Certificate of Appropriateness

| Property | 959 N. 34TH ST. Concordia |
| Date issued | 8/15/2019 PTS ID 114820 COA: porch restoration. |

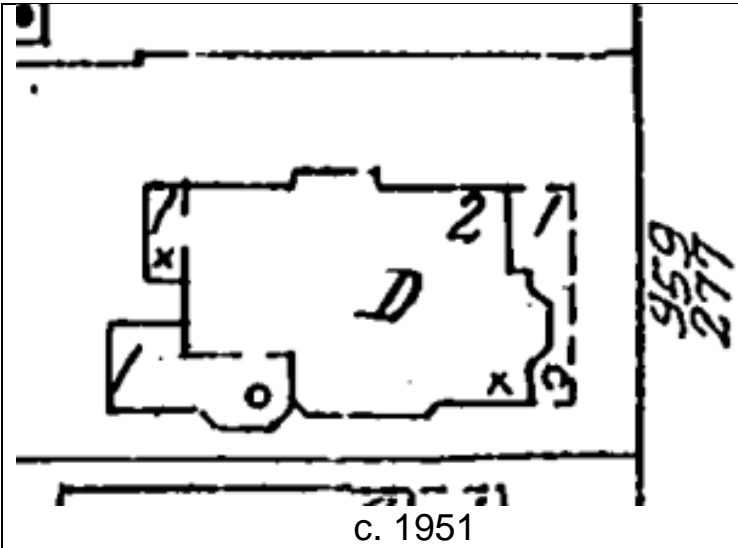
Capitals for new fluted porch columns will be of this design in a natural material (e.g., wood, plaster, stone)

Porch design to be replicated to this c.1979 photo.

Replacement stone.

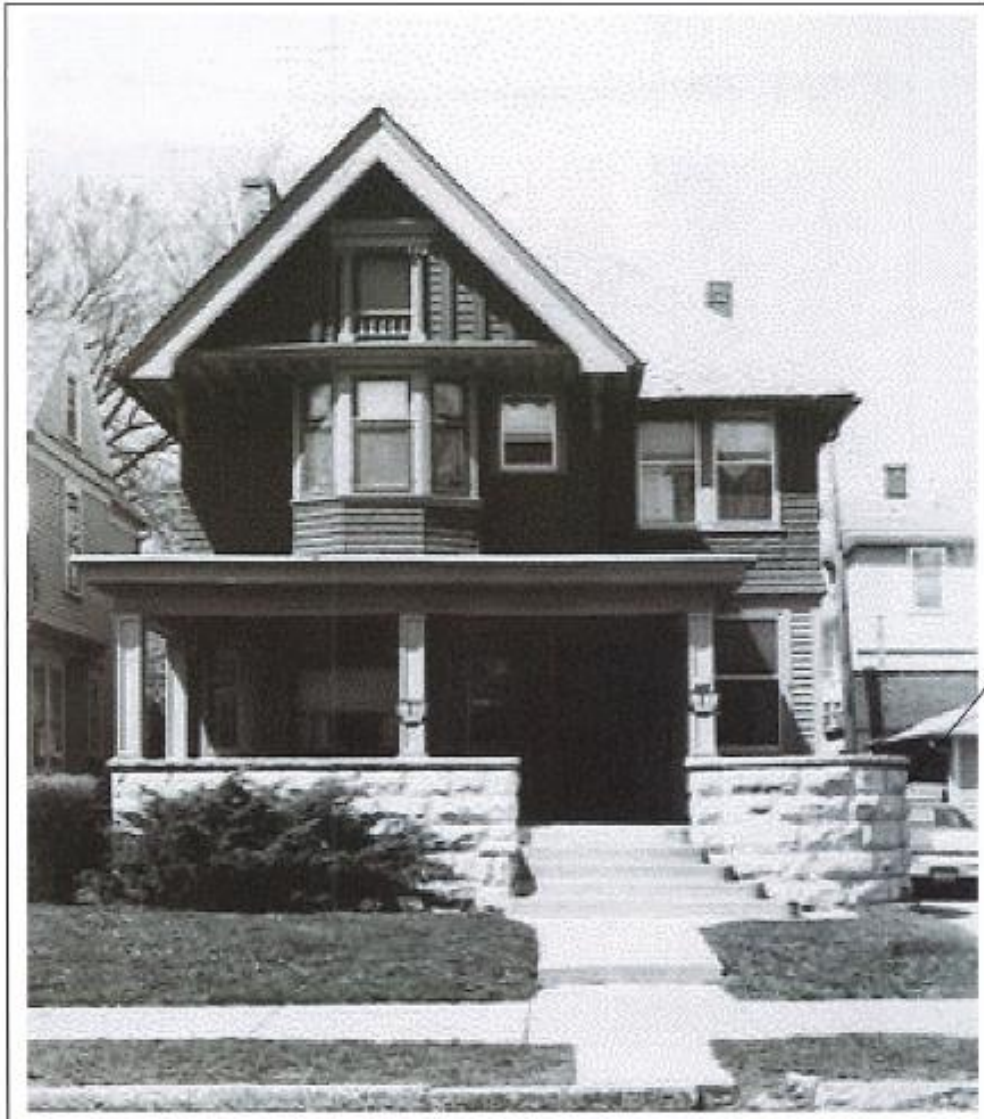
Front porch will be carefully deconstructed and rebuilt using the same stone. The stone walls are five courses high with an interior of brick.

Disregard columns on this page.
